1997 - 1998 Corvette: Service Bulletin: Fuel Pump Noise Coming From Fuel Pump/Tank (Replace Fuel Pump Assembly)

Number: 83-63-10 - (04/28/1998)

Models: 1997-98 CHEVROLET CORVETTE BUILT PRIOR TO VIN BREAKPOINT 07561

Figure 1

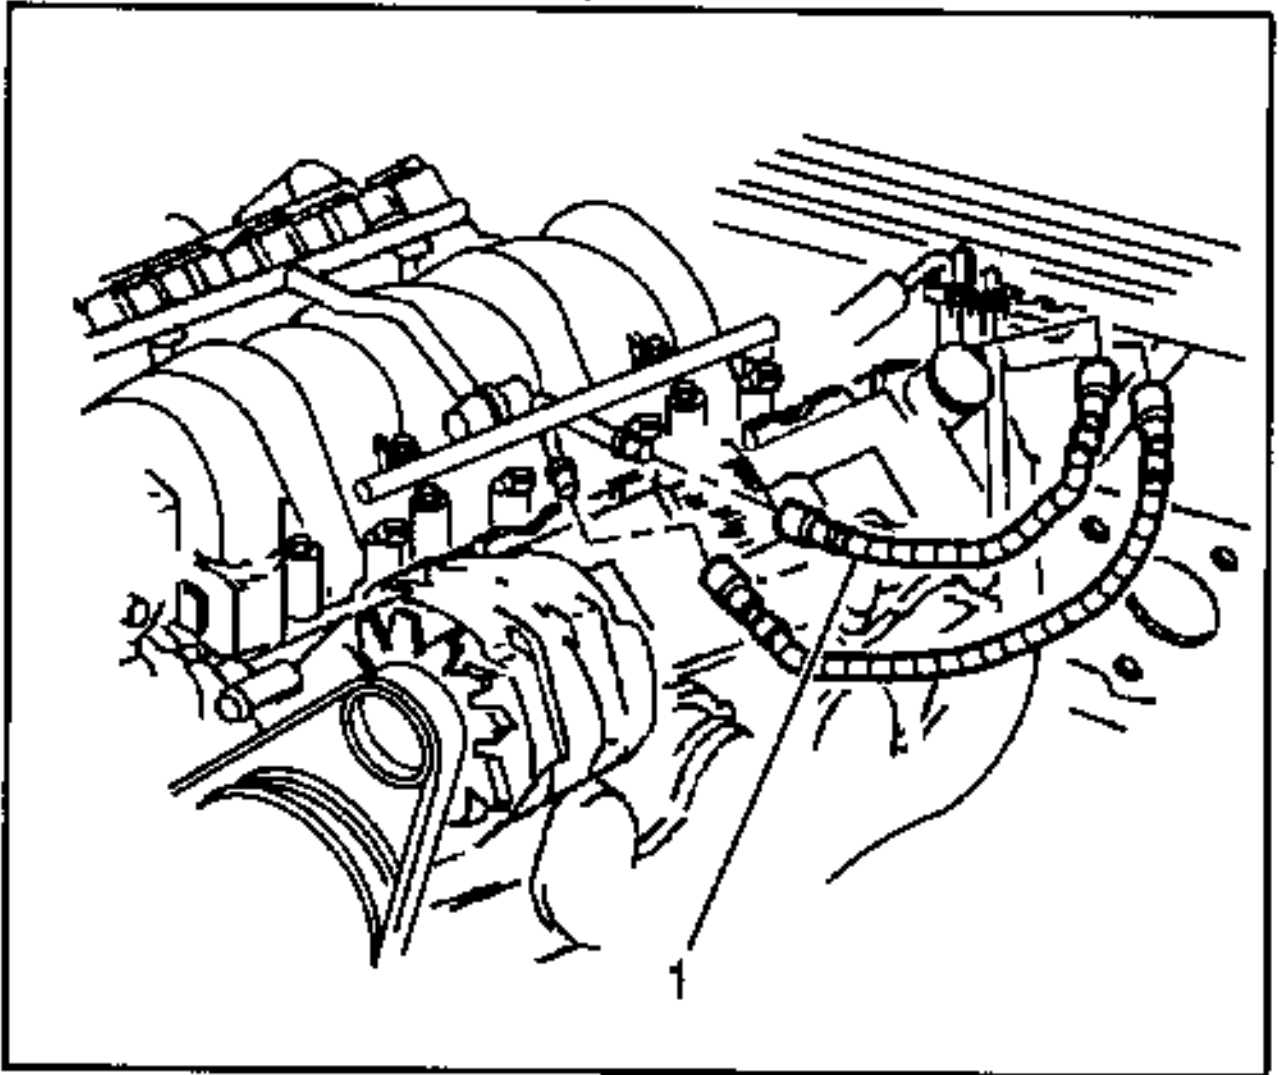
8. DISCONNECT THE FUEL RETURN HOSE (4) FROM THE FUEL RAIL (FIGURE 1).

12. RECONNECT THE FUEL RETURN HOSE (4) TO THE FUEL RAIL (FIGURE 1).

Figure 2

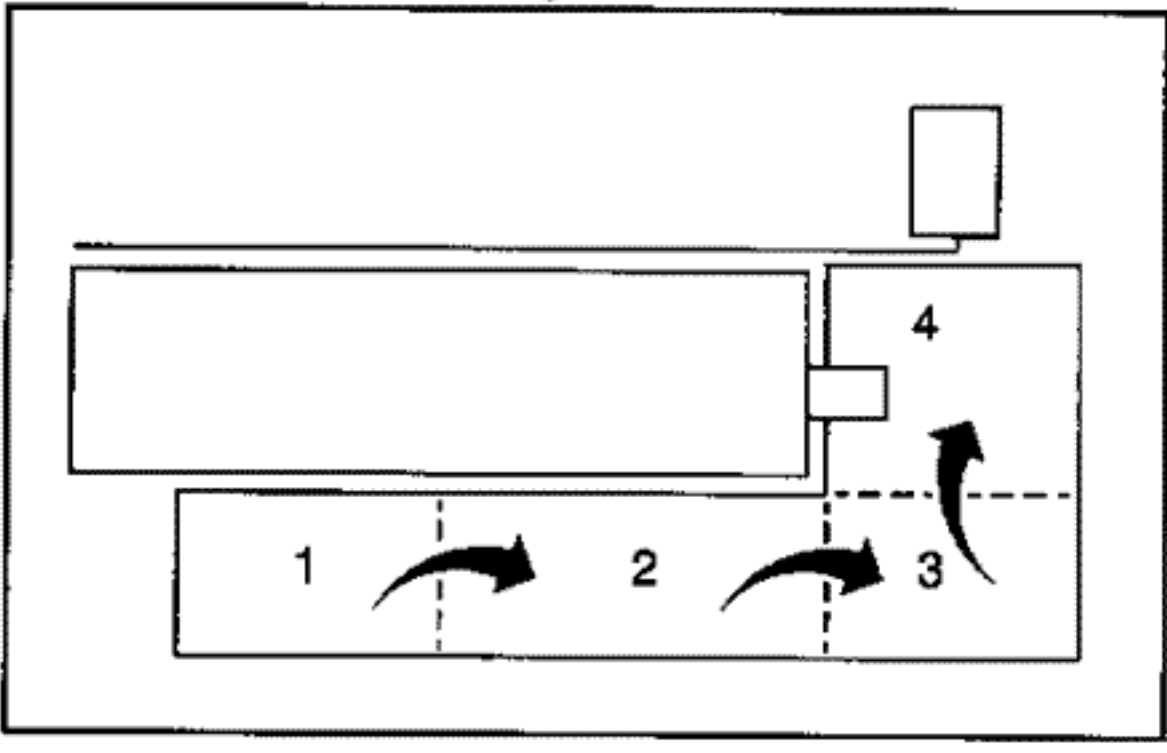
3. FOLD THE STRAINER THREE TIMES SO THAT THE AMOUNT OF SPACE OCCUPIED BY THE STRAINER IS ABOUT EQUIVALENT TO THE DIAMETER OF THE FUEL SENDER RESERVOIR (FIGURE 2).

- A. FOLD THE LONG SIDE OF THE STRAINER OVER (1 OVER 2).
 - B. FOLD 3 OVER 4 AND HOLD THE STRAINER IN THE FOLDED [loz] POSITION.
4. INSERT THE FUEL SENDER THROUGH THE FUEL TANK OPENING.
 5. RELEASE THE STRAINER ONCE THE STRAINER IS IN THE FUEL TANK. THE STRAINER WILL SPRING BACK TO ITS FULL POSITION.
 6. CONTINUE INSERTING THE FUEL SENDER THROUGH THE FUEL TANK OPENING. IT MAY BE NECESSARY TO ROTATE THE FUEL SENDER IN ORDER TO FACILITATE THE INSTALLATION.
 - A. LOOK THROUGH THE FUEL TANK OPENING TO ENSURE THAT THE [loz] LONG SIDE OF THE STRAINER IS VISIBLE.
 - B. IF THE STRAINER IS NOT VISIBLE, ROTATE THE FUEL SENDER [loz] CLOCKWISE AND COUNTER CLOCKWISE ABOUT 90 DEGREES. [loz] ROTATING THE FUEL SENDER WILL FREE UP THE STRAINER. [loz] THE STRAINER SHOULD BECOME VISIBLE AT THE TANK [loz] OPENING.

Figure 3

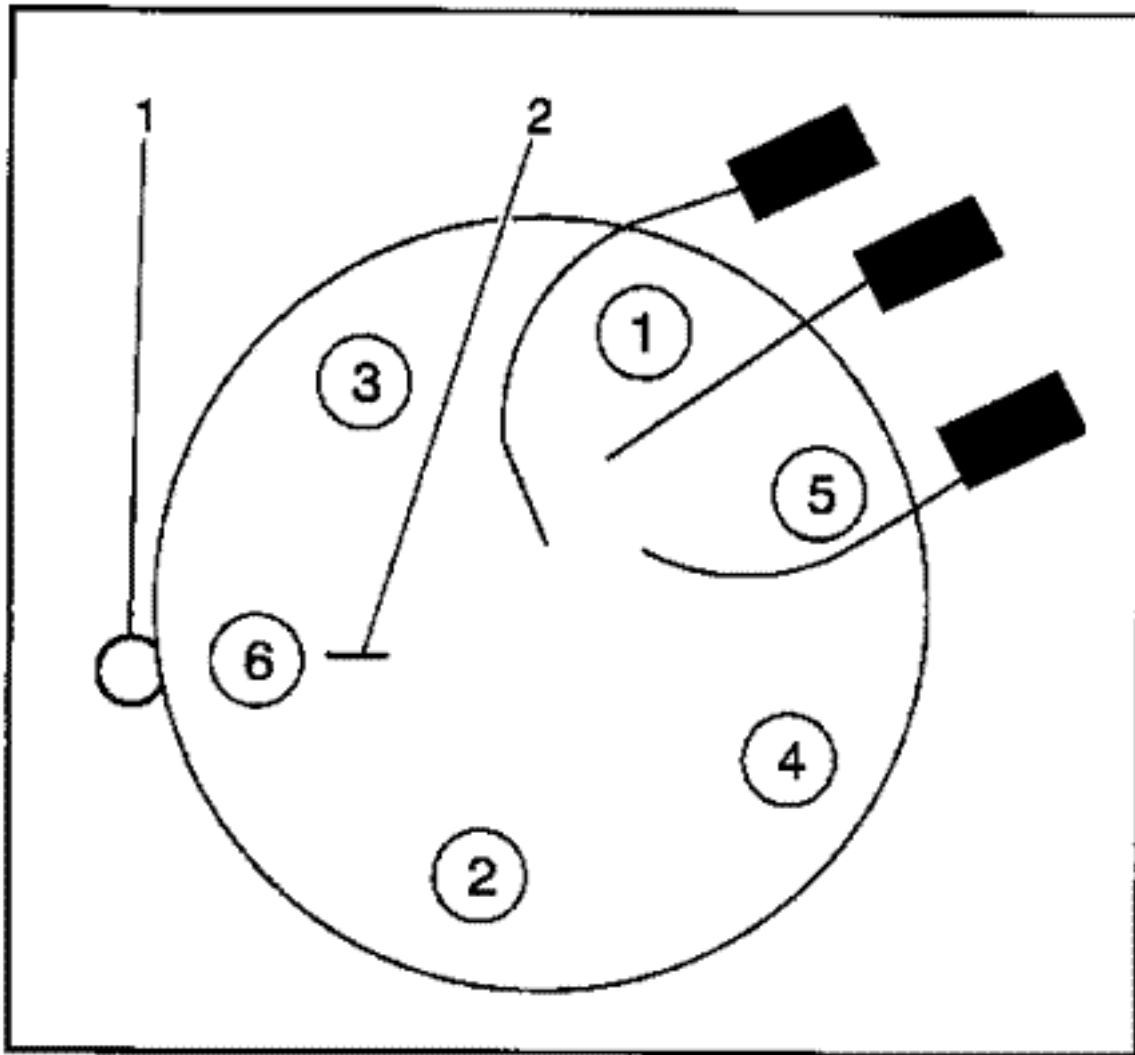
- DO NOT BEND OR TWIST THE FLOAT ARM.
7. INSERT THE FLOAT AND THE FLOAT ARM INTO THE FUEL TANK OPENING.
 8. INSTALL THE FLOAT ARM ON THE FUEL SENDER.
 9. INSTALL THE FLOAT ARM RETAINING CLIP.
 10. ALIGN THE FUEL SENDER GASKET TAB (1) WITH THE FUEL SENDER COVER MARK (2). (FIGURE 3)
 11. ALIGN THE FUEL SENDER COVER MARK (2) WITH THE FUEL TANK MARK. (FIGURE 3)

12. HAND TIGHTEN THE FUEL SENDER ATTACHING BOLTS UNTIL FINGER TIGHT. USING THE FUEL SENDER TORQUE TOOL (J 42940), TIGHTEN THE FUEL SENDER ATTACHING BOLTS TO 3 N.M IN THE SEQUENCE SHOWN IN (FIGURE 3). J 42940 WILL RATCHET WHEN THE PROPER TORQUE IS ATTAINED.

Figure 4

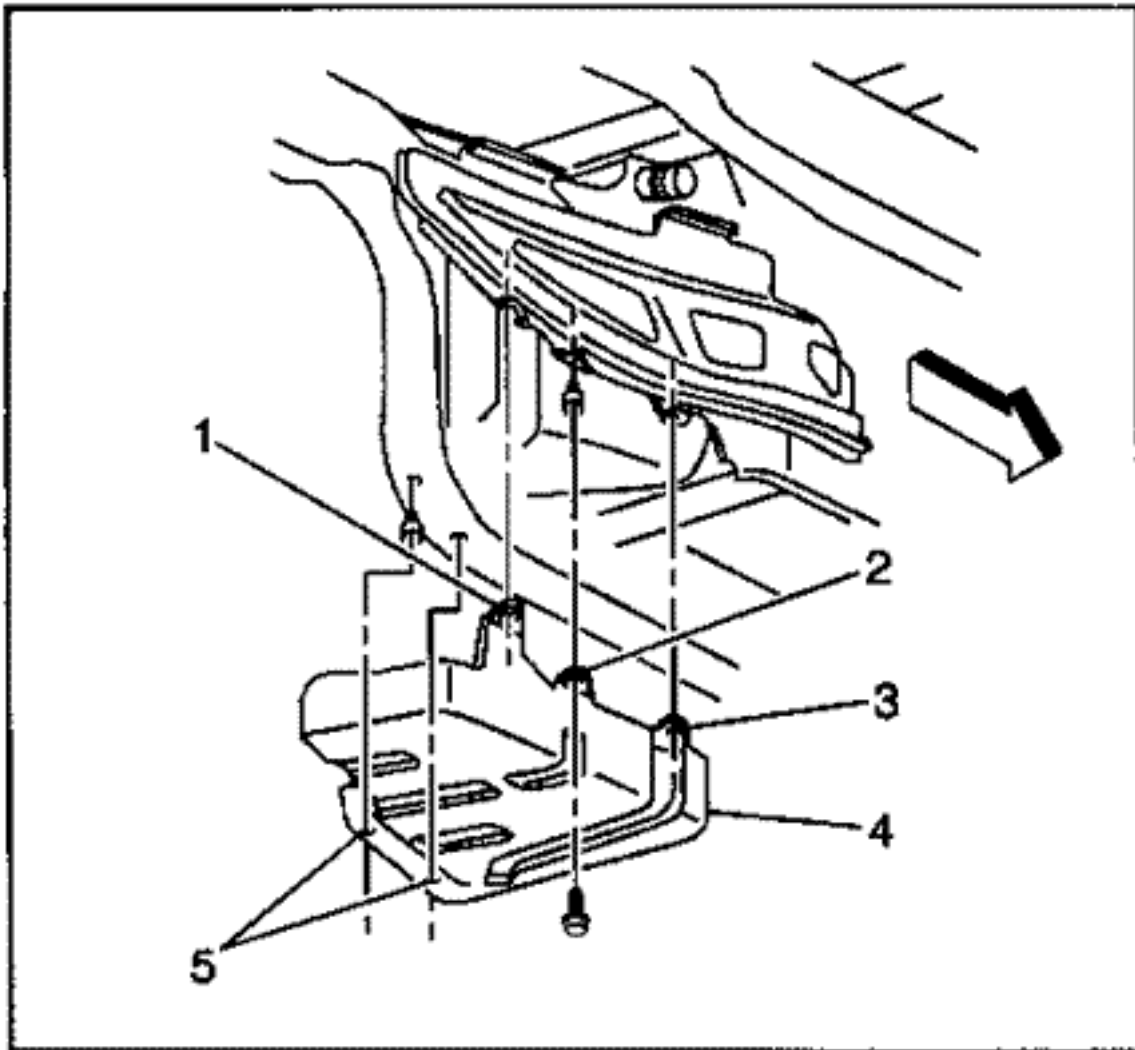
17. INSTALL THE FUEL TANK STRAP/SHIELD BOLTS (FIGURE 4).

A. INSTALL THE NET HOLE BOLT (3).

B. INSTALL THE SLOT LOCATION BOLT (1).

C. INSTALL THE REMAINING BOLTS (2 AND 5).

[loz] TIGHTEN THE FUEL TANK STRAP/SHIELD BOLTS TO [loz] 25.5 N.M (19 LB FT).
